Noise and Vibration Feasibility Study

Proposed Residential Development, Arkell Subdivision, South of Arkell Road and East of Watson Road South, Puslinch, Ontario

June 1, 2026
HGC Project #: 02600117

APPENDIX G – Peer Review dated April 21, 2026 and HGC's Responses

Figure 1: Key Plan

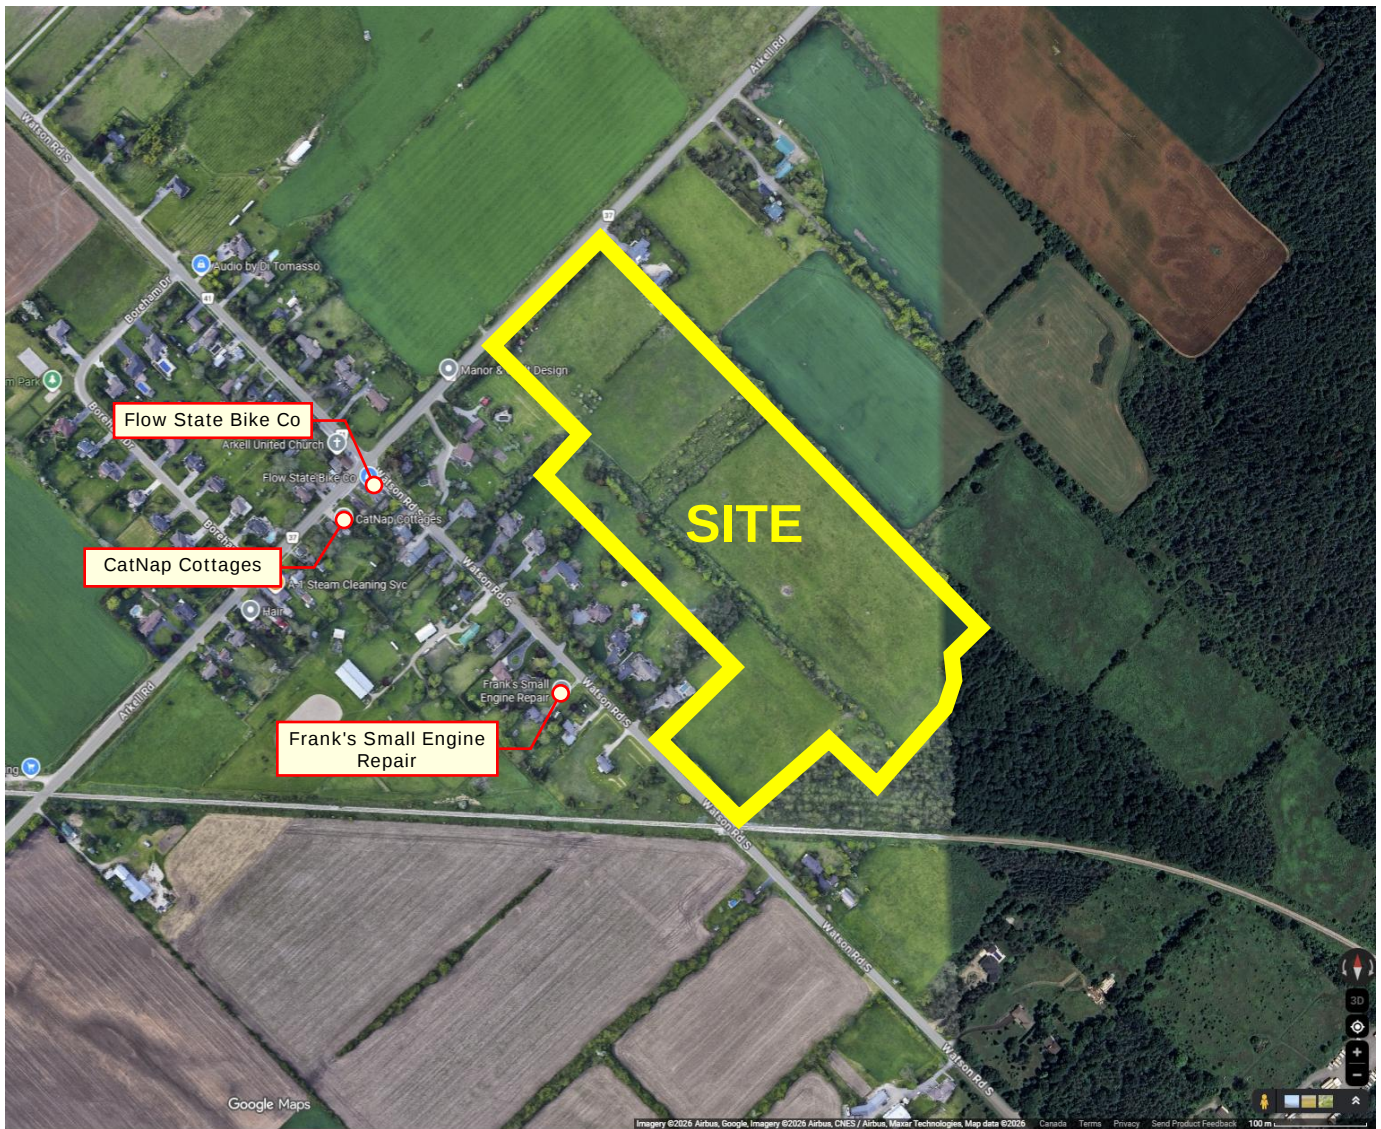
- b. The noise study indicates there are existing stationary sources (i.e., small engine repair shop, bicycle store and pet boarding service) in the area. These need to be identified on a Key Plan to confirm there are existing noise sensitive uses that are closer to these than the proposed residential development as stated in the noise report.

Figure 1, the Key Plan, has been updated.

Figure 3: Proposed Concept Plan Showing Ventilation and Acoustic Barrier Requirements

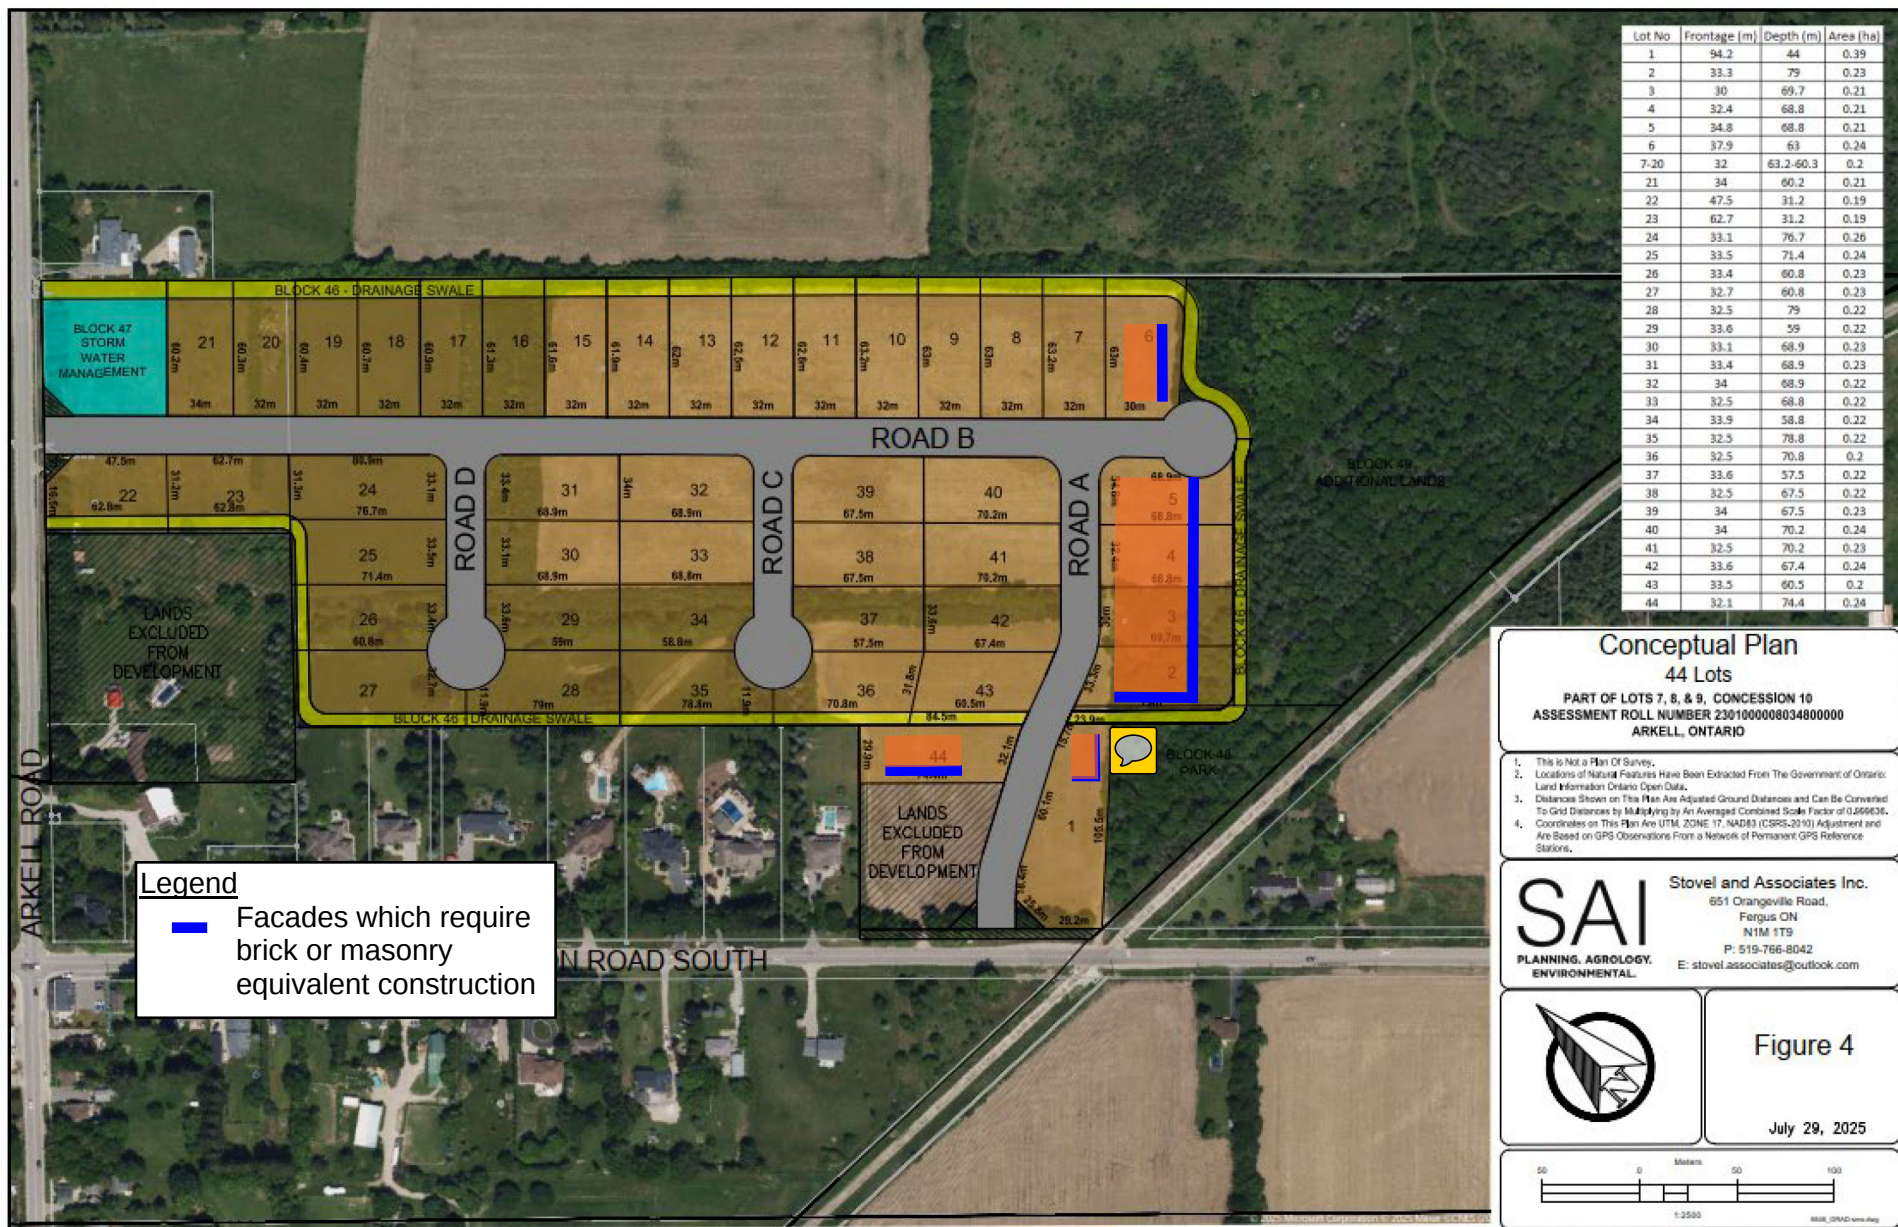
- f. The noise mitigation summary provided as Table 7 should include the locations where brick veneer or equivalent masonry construction is required for the exterior walls. Review of the recommended locations shown on the first Figure 4 indicate that in addition to the southeast façade, the southwest façade should also be brick veneer or equivalent masonry construction.

The table is reprinted here with the extra column. Figure 3 is attached.
